**TOWN OF PORTOLA VALLEY
ARCHITECTURAL AND SITE CONTROL COMMISSION (ASCC)
Monday, November 24, 2014
7:30 PM – Regular ASCC Meeting
Historic Schoolhouse
765 Portola Road, Portola Valley, CA 94028**

MEMORANDUM

RE: Architectural Review and Site Development Permit for a New Residence, Second Unit, Pool House, and Swimming Pool, File # 44-2014, APN: 079-220-010, 40 Antonio Court, Melton Residence

A1.1

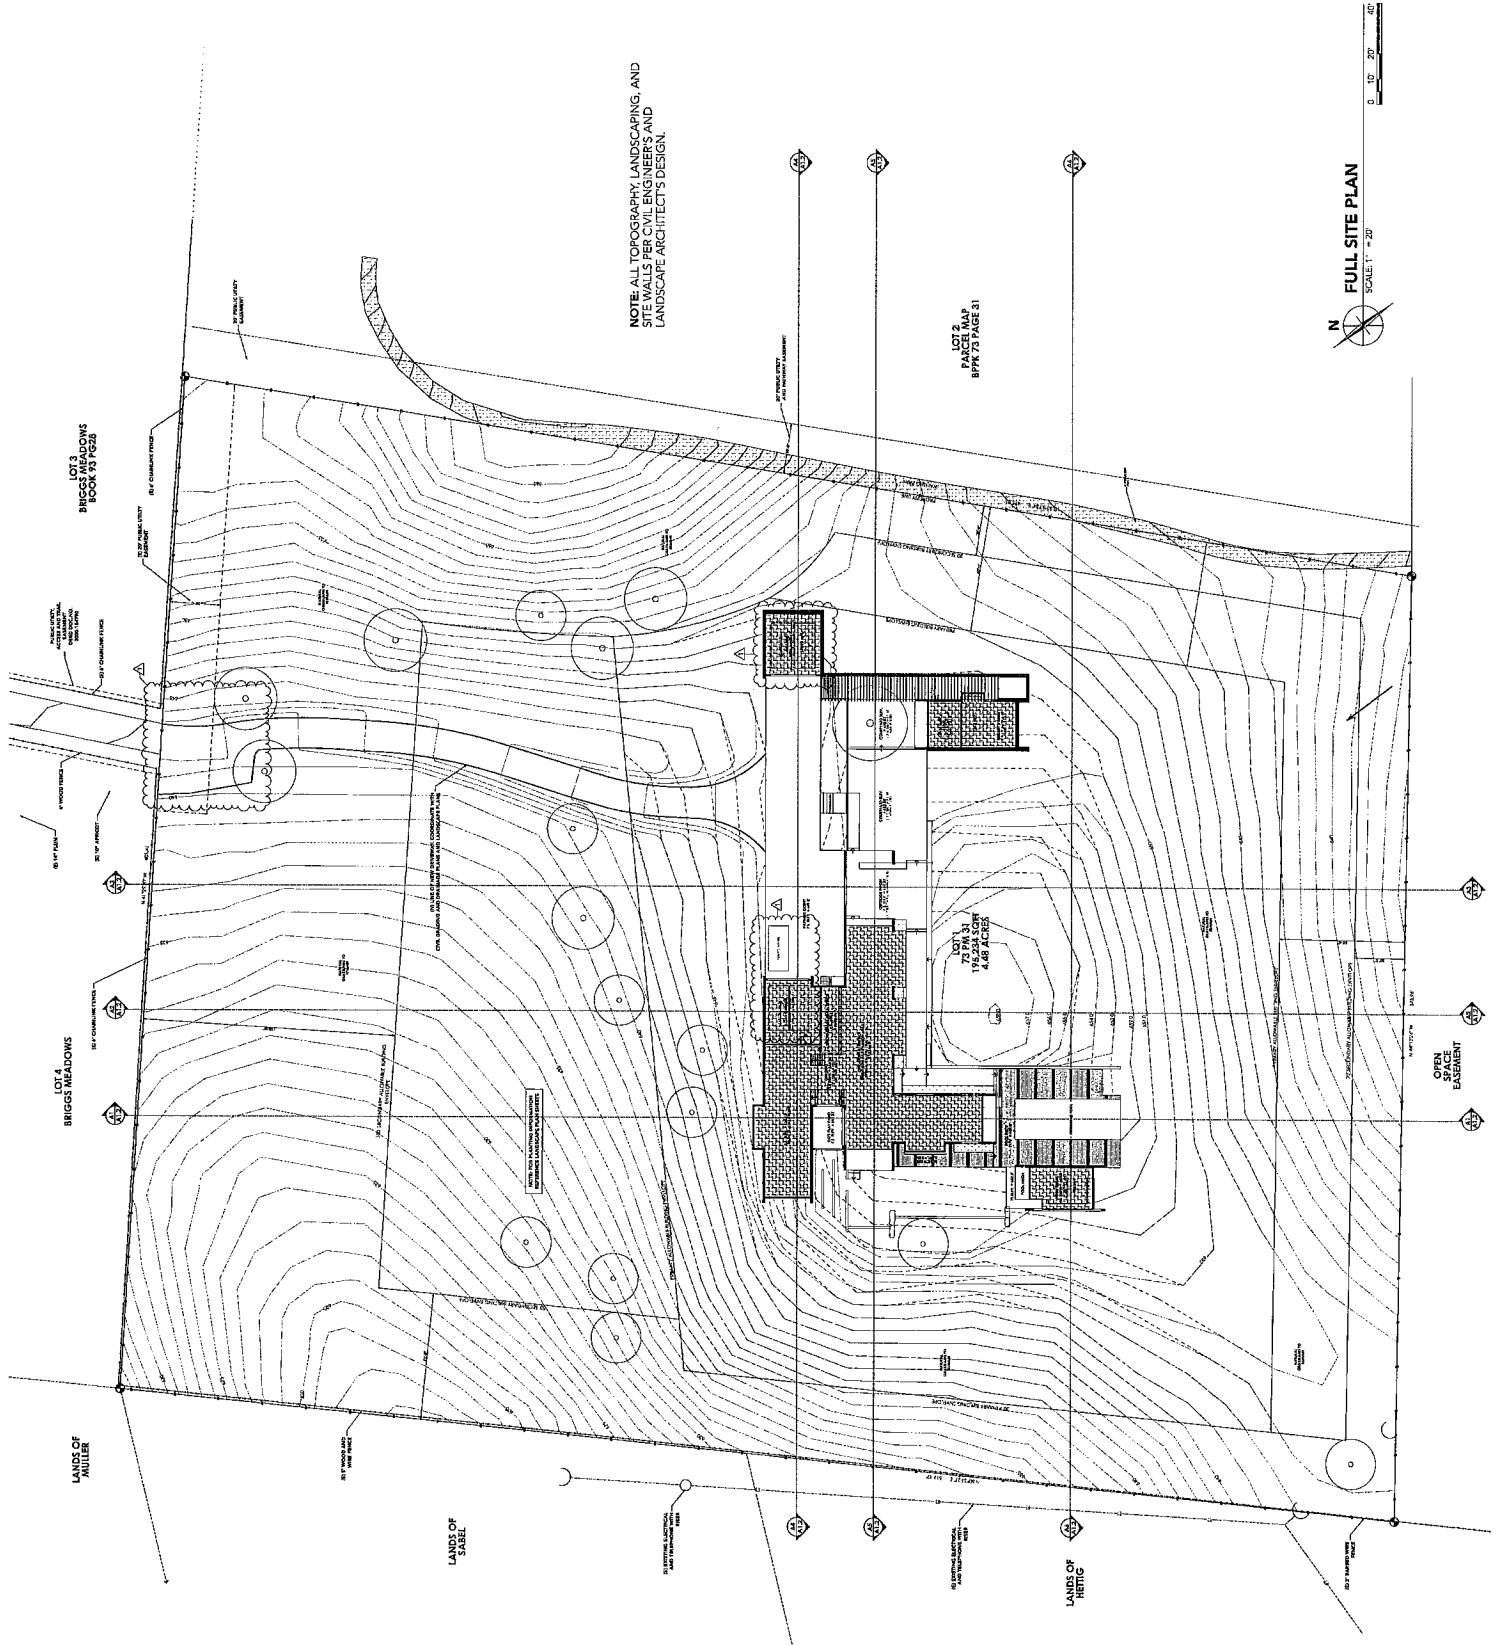
Parking. Required parking in the R-E/1A zoning district is 2 covered spaces and 2 guest spaces plus 1 addition guest space for the second unit. The applicant is proposing 4 covered spaces in the garages. The additional guest parking space can be accommodated in the auto court between the garages but should be called out on the site plan.

Required parking in the R-E/1A zoning district is 2 covered spaces and 2 guest spaces plus 1 addition guest space for the second unit. In response to comments in the November 10th staff report, a fifth parking space has been added in front of the attached garage. However, pursuant to Portola Valley Municipal Code Section 18.60.020.A (Required parking for dwellings), tandem parking is not allowed because "unobstructed vehicular access shall be provided to each parking space." To comply with the Town's parking requirements, the fifth parking space should be relocated to the area on the auto court directly north of the living room and shall not encroach within the required fire truck turnaround. (Condition #3)

A2.2

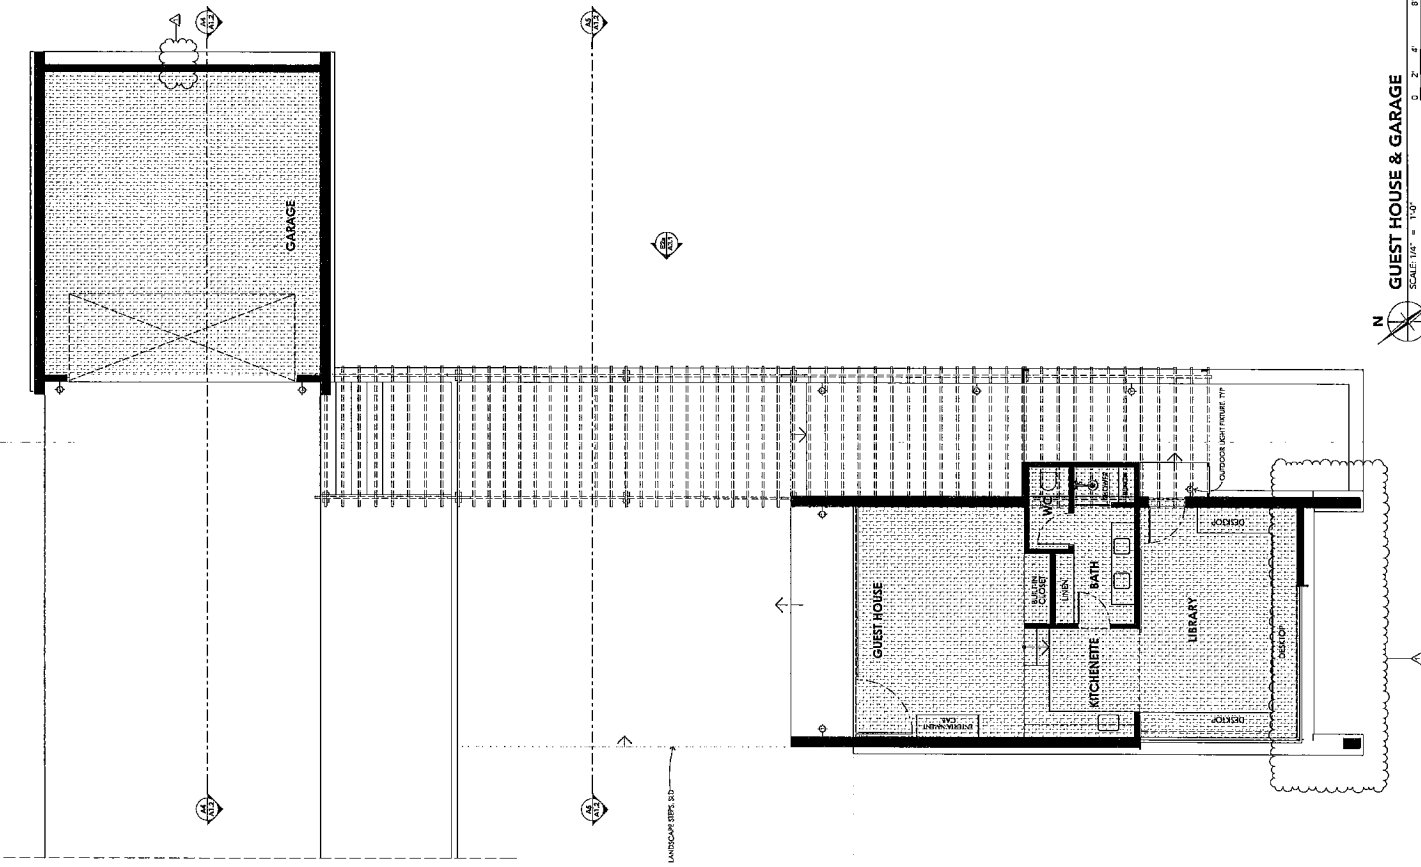
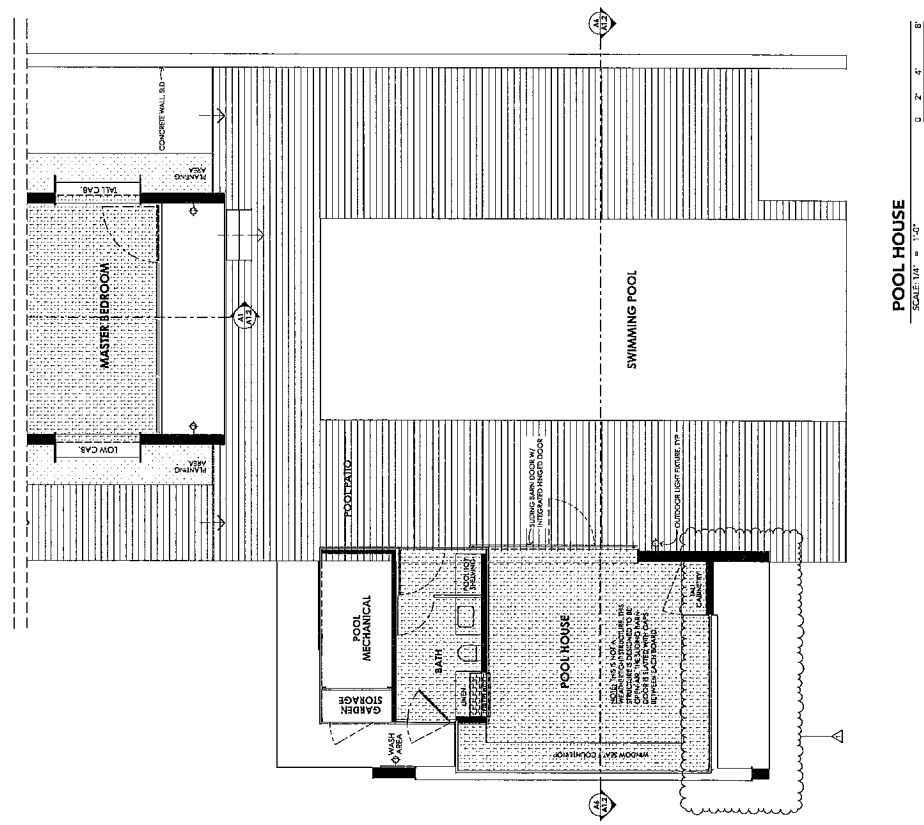
Chair Koch said the project is attractive and thoughtfully designed according to the requirements of the PUD. She had no concerns about the colors and materials but the number of lights should be reduced. She believed that the linearity of the house is causing concerns for the neighbors but lowering house is not going to make much of a difference. She questioned the need for the number of windows at the garage as well as the gate at the entrance to the property. She said the flat roof concept over the outdoor room would break up the continuous roof line and cause a design issue. She had no concerns with the landscape plan but suggested that the applicant work closely with the neighbors on adding significant trees for screening.

At the request of Chair Koch, pool and hot tub lights have been included on the landscape lighting plan (Sheet 2.0). In addition, a total of 8 outdoor lights have been removed including 5 path lights in the lawn and vegetable garden areas at the west end of the house, 1 wall light in the rear of the detached garage, and 2 wall lights each on the guest house and the pool house. (Sheet A2.2)

A2.3

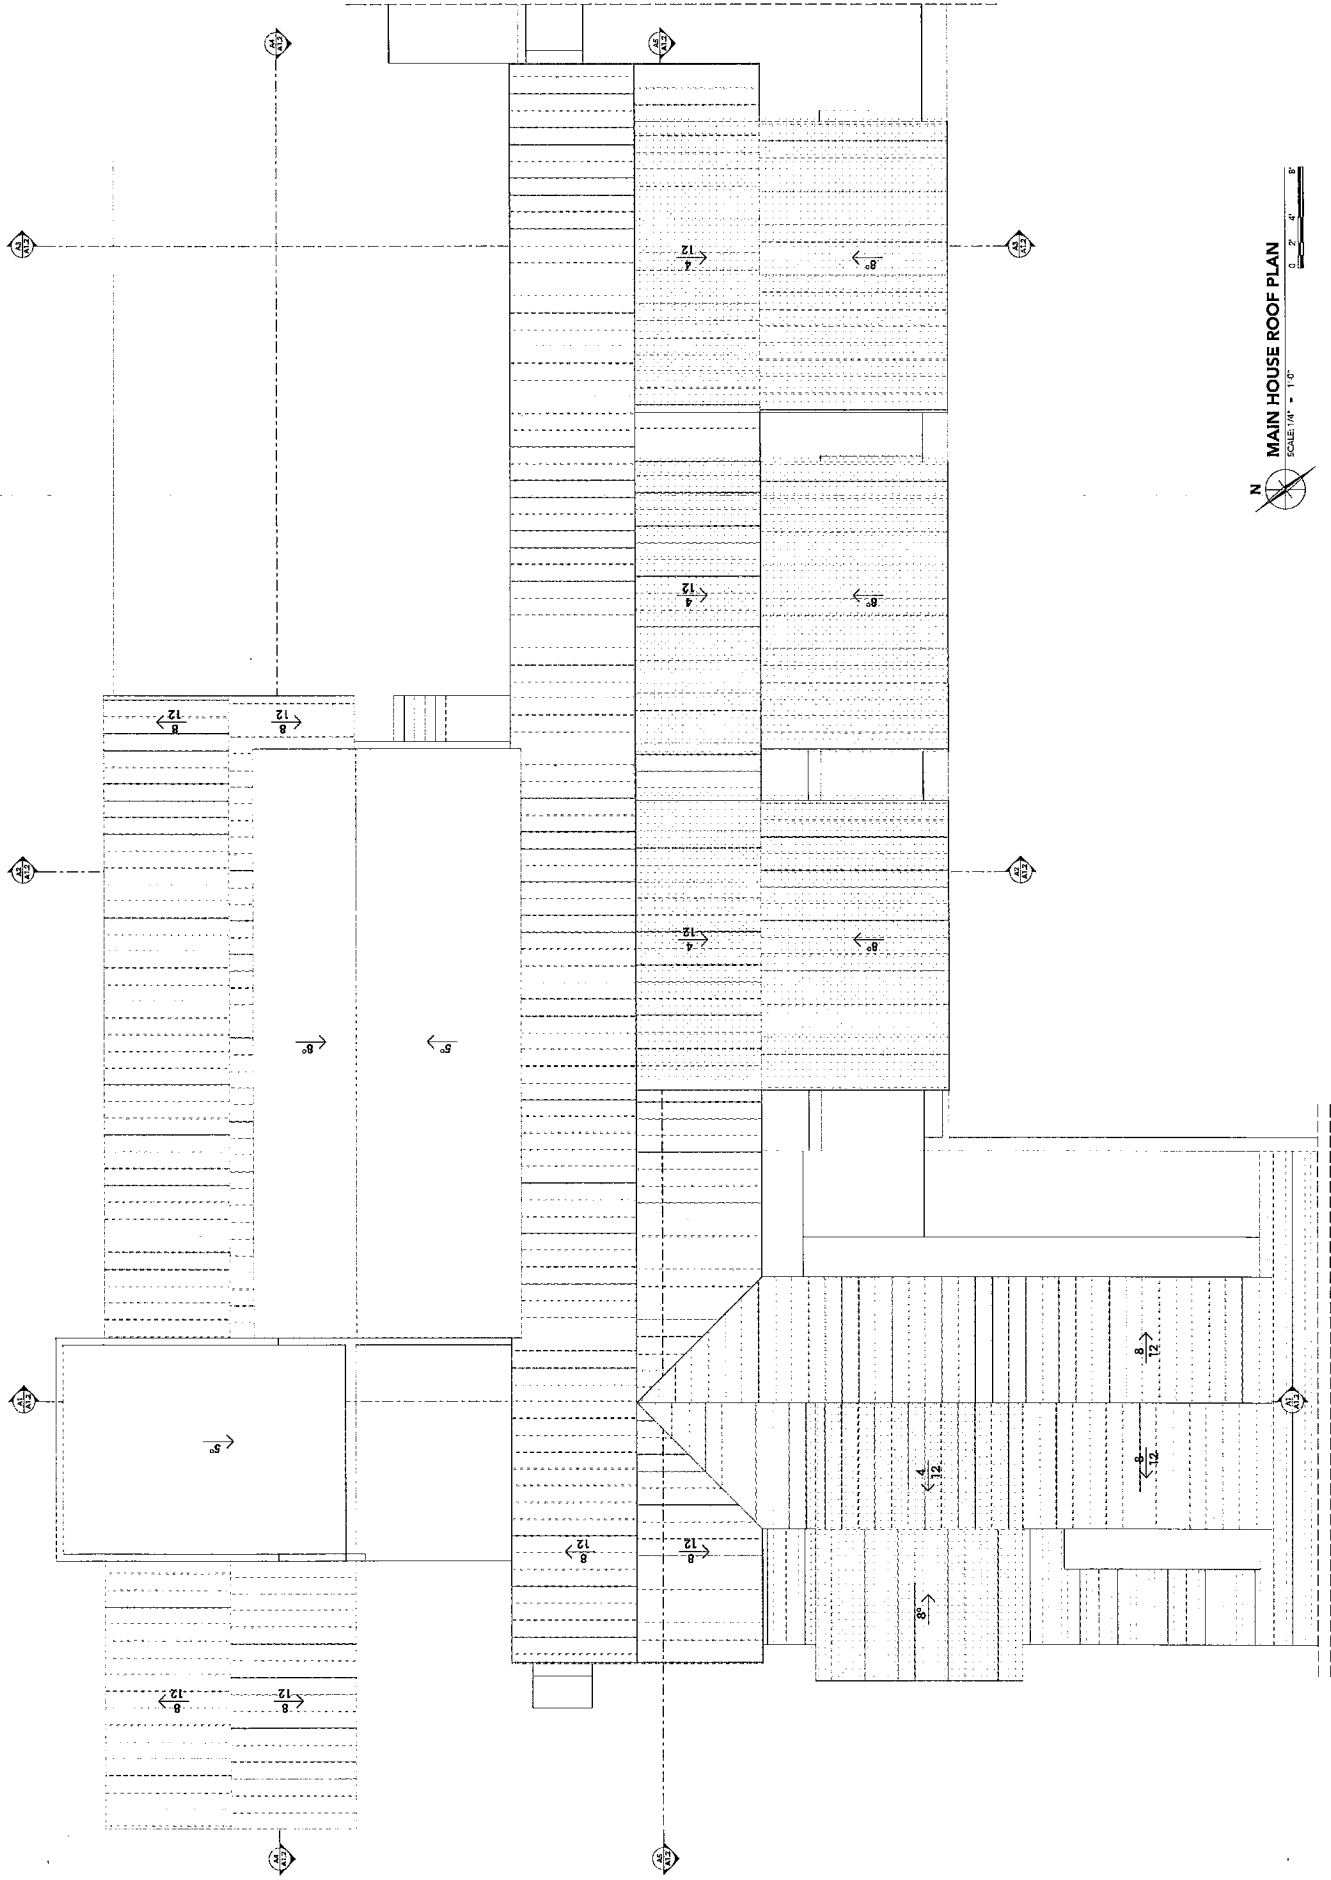
Commissioner Clark noted that a roof plan should be included. He also suggested that a rendering for driveway approach be prepared.

At the request of Commissioner Clark, a roof plan has been included (Sheets A2.3 and A2.4). No change has been made to the roof pitch to reduce the height of any of the buildings.

LANDSCAPE SITE PLAN

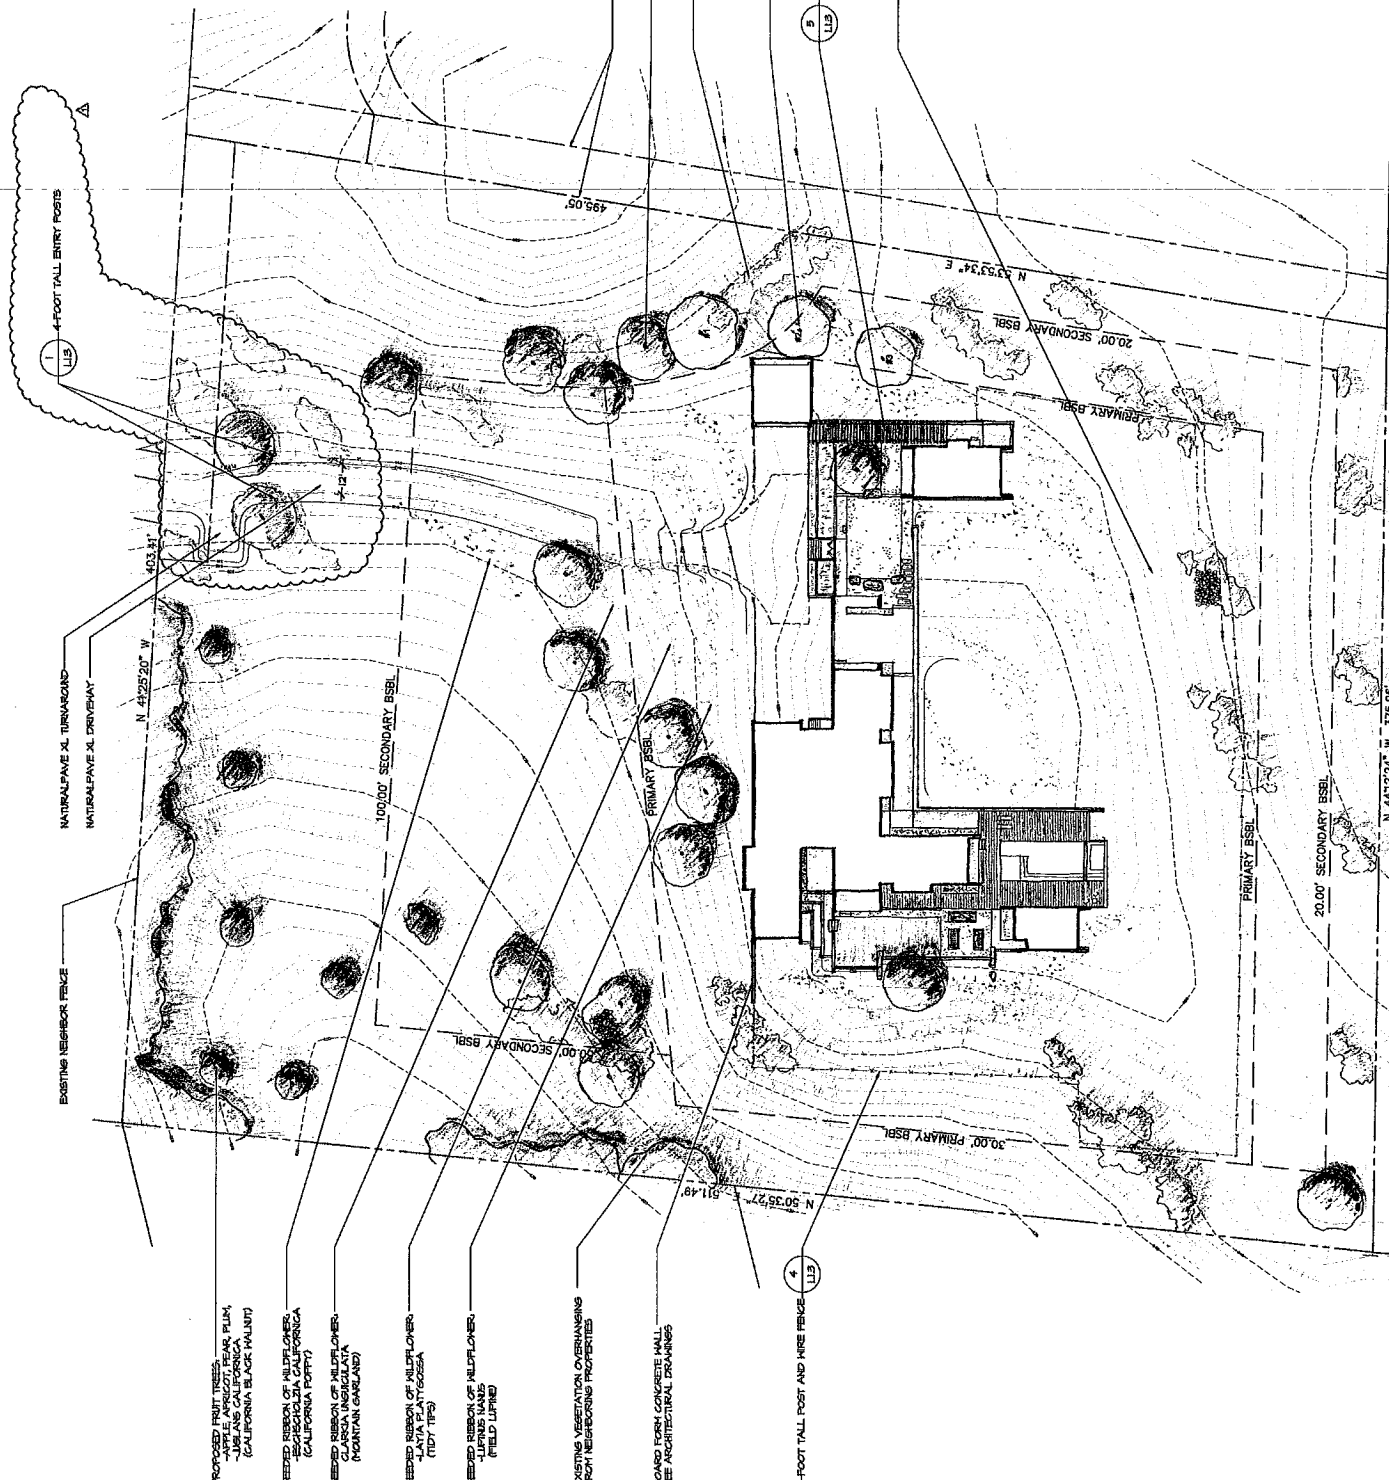
Chair Koch closed the public hearing and summarized Commissioner Breen's email comments for the project. Breen said the building forms, simplicity of the design, and the palette of materials are lovely. She appreciated the thoughtful approach to siting but also suggested lowering the roof or plate height and possibly moving or eliminating the detached garage. She preferred fewer oaks to be planted on the property as they may block the Mackowski's view of the meadow.

No substantive change has been made to the proposed landscape plan Sheet L1.0 which shows the preservation of 3 medium size coast live oaks east of the detached garage. The conceptual landscape design for this project includes new oak trees to be planted along the north and east sides of the house for screening and fruit trees near the northern corner of the property. The size of the 15 coast live oaks and 1 blue oak to be planted on this site are not called out on the plans and a note on Sheet L1.0 indicates that the final placement of the proposed trees will be determined on site in order to maximize screening.

To address neighbor concerns regarding the visibility of the house, it is recommended that a final landscape plan showing the size and location of all proposed screen trees be submitted for ASCC review. (Condition #4)
